# Cohasset Planning Board Hearing

## Peer Review

## Site Plan Review and Special Permit

124 & 87 Elm Street

RENDERING FROM APPLICANT

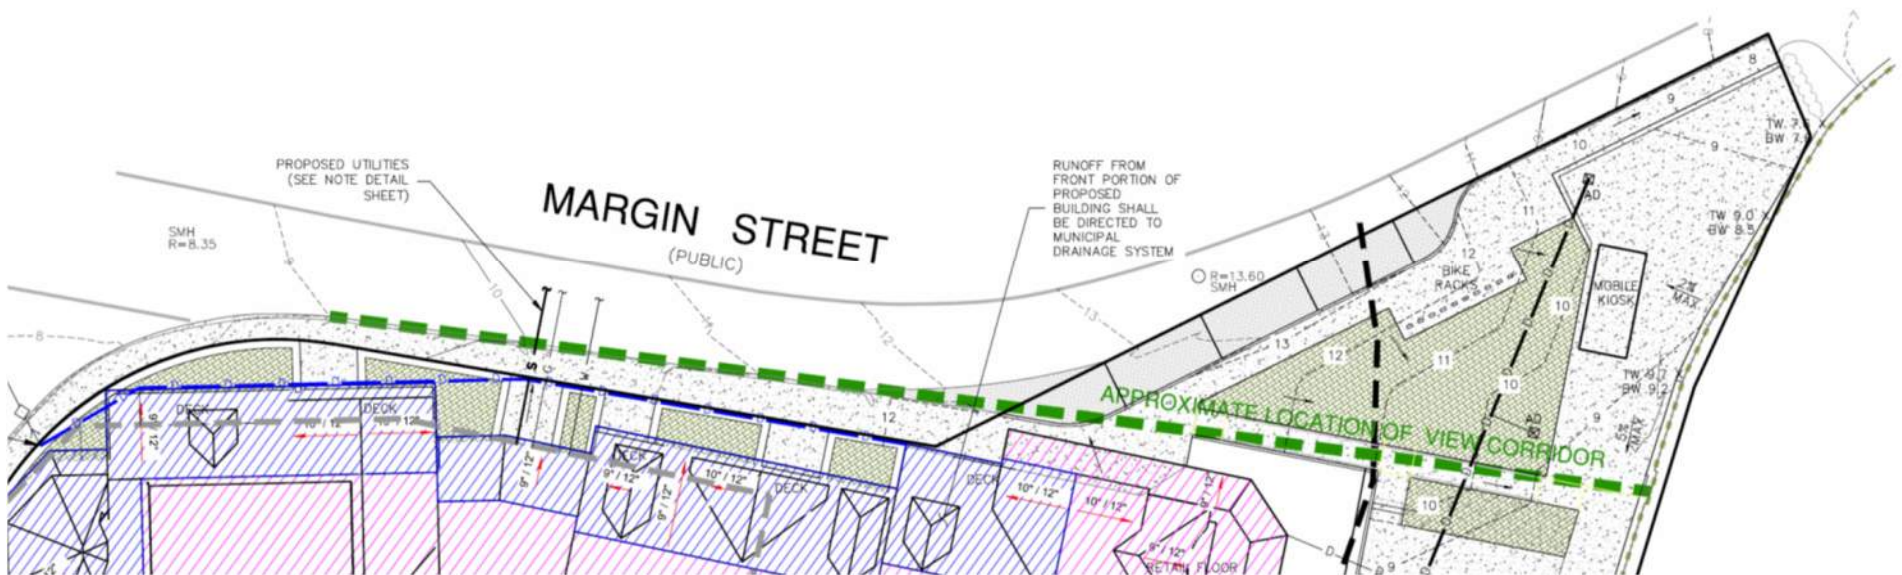
- Proposed Parallel Parking on Elm Street<sup>(1.3.8)</sup>
  - Clarify the parallel parking that varies between plans
  - Traffic study includes minimum safety requirements - stopping sight distance
  - Applicant noted required improvements are off-property, change in use of Elm Street necessitates improvements
